DEVIATION REQUEST AND DECISION FORM

Project Name : Claremont Business Park 2 Filing No. 2

A deviation from the standards of **Table 2-7. Roadway Design Standards for Urban Collectors and Locals-** of the Engineering Criteria Manual (ECM) is requested.

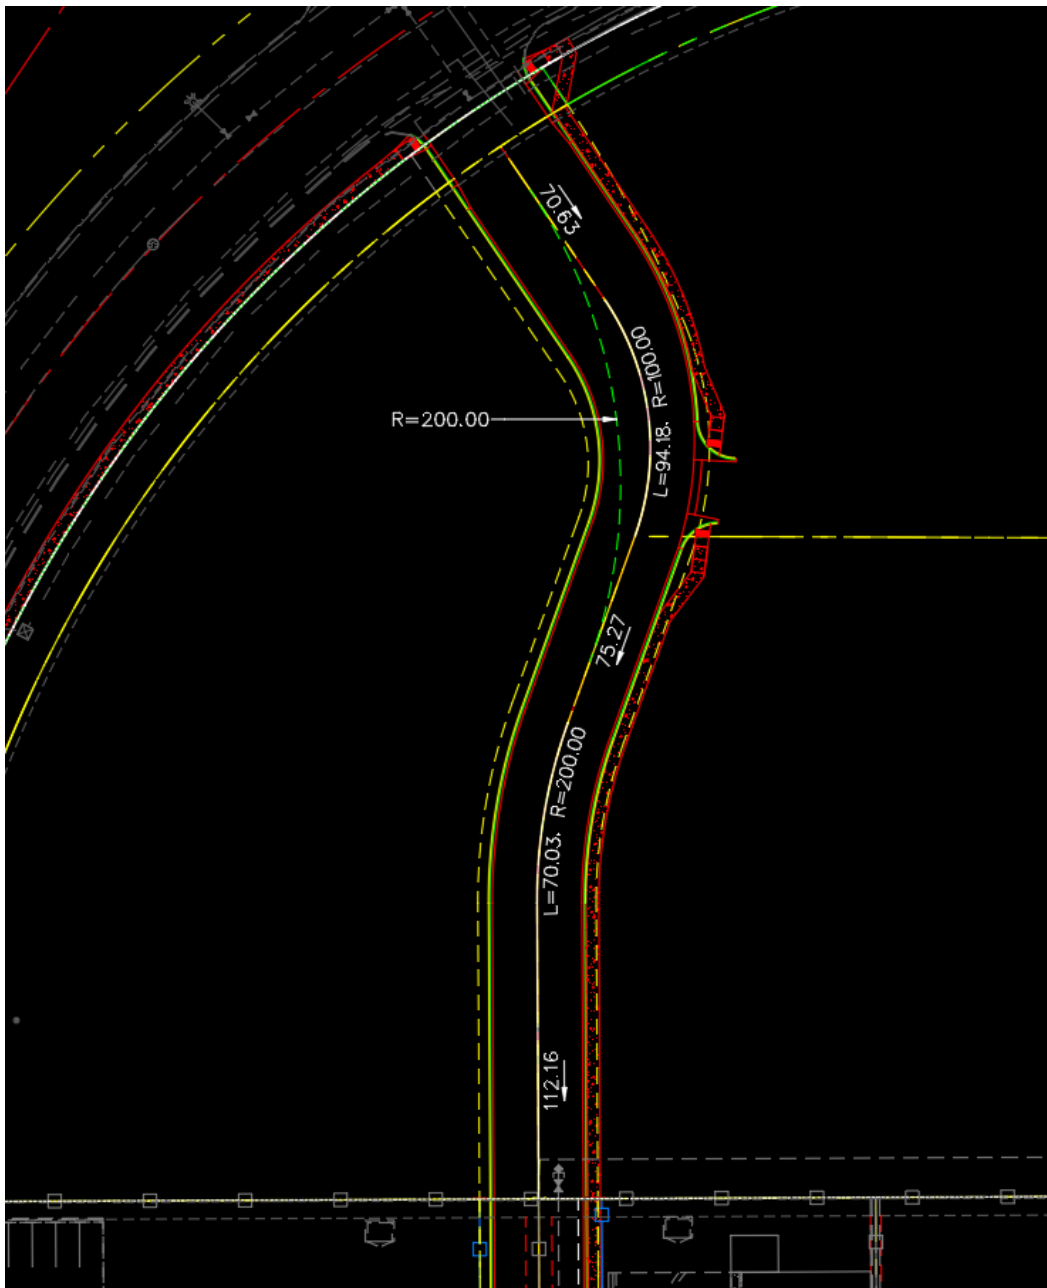
- 100' minimum centerline radius whereas a standard minimum centerline radius is 200'.

- We request approval of a 100' minimum centerline radius, whereas the radius requirement is 200' at (1) one (north curve) curvilinear location within the El Jefe Heights roadway. Meeting the 200' radius requirement would inhibit adequate distance between the two proposed curves. See the image below of the proposal for the 100' vs. the 200' radius requirement.

The reduced radii 100' curve (north) is located approx. 100' from the intersection of El Jefe Heights and Meadowbrook Pkwy. The reduced curve radii are expected to have minimal effect on the roadway operation, as northbound is an approach to a "stop" condition, and southbound, the speed of traffic southbound from Meadowbrook Pkwy is anticipated to be relatively slow in the direction of the reduced radii curvature.
